# MATANUSKA-SUSITNA BOROUGH

# STAFF REVIEW AND RECOMMENDATIONS **PUBLIC HEARING SEPTEMBER 10, 2025**

**HAWKS NEST**

CASE #: 2025-117

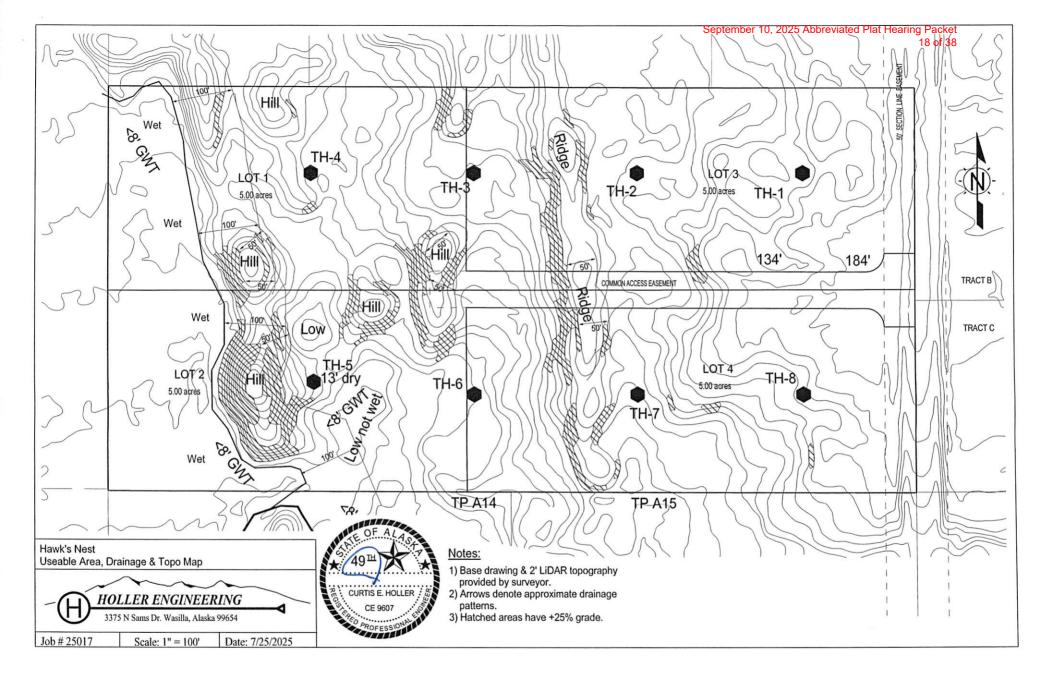
<u>Topography.</u> The project site forms a rectangle west of S Kenlar Road. The parent parcel contains gently rolling terrain with minor ridges. The lowest areas lie along the west end adjacent to a large wetland. Several areas containing steep slopes exceeding 25% were noted and are delineated on the attached map. The total elevation differential indicated by the provided topographical map is approximately 40'.

Roads and Drainage. The proposed 4 new lots will each be accessed by driveways onto an existing maintained road, and as such will not require the creation of any new roads. As no new roads are proposed, a full drainage plan is not required; however, existing drainage patterns have been indicated on the attached map. The project will minimally affect drainage patterns in the area.

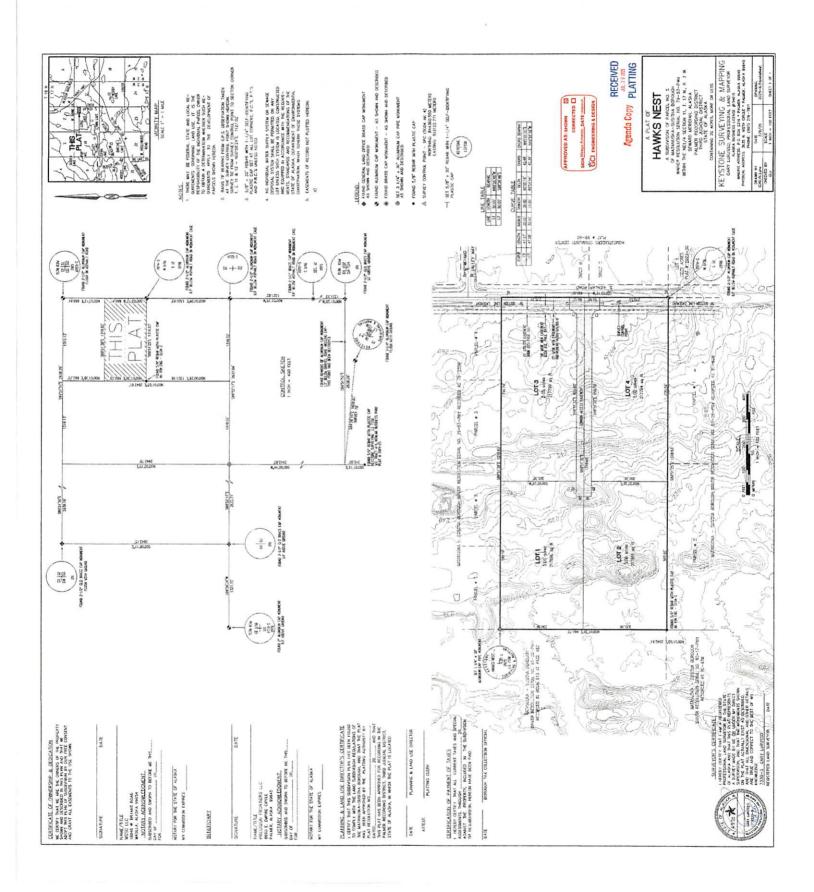
In review GCI has no comments or objections to the plat, attached is the signed plat for your records.

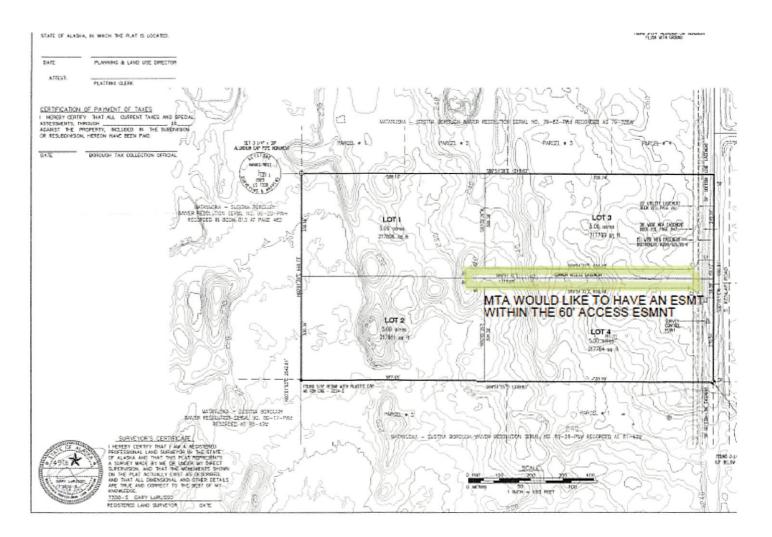
MTA requests an easement within the 60' access easement (Recommendation #4).

MTA has reviewed Hawks Nest and would like to comment/request the following:

Platting staff notes that an abbreviated plat cannot grant public utility easements. The petitioner will need to grant the requested easement by document and show it on the final plat. Pursuant to MSB 43.20.300(E)(3) Utility easements and utilities shall be located outside of the length of the flag pole portion of the lot (a) excepting where the flag pole is greater than 75 feet wide to accommodate utilities.
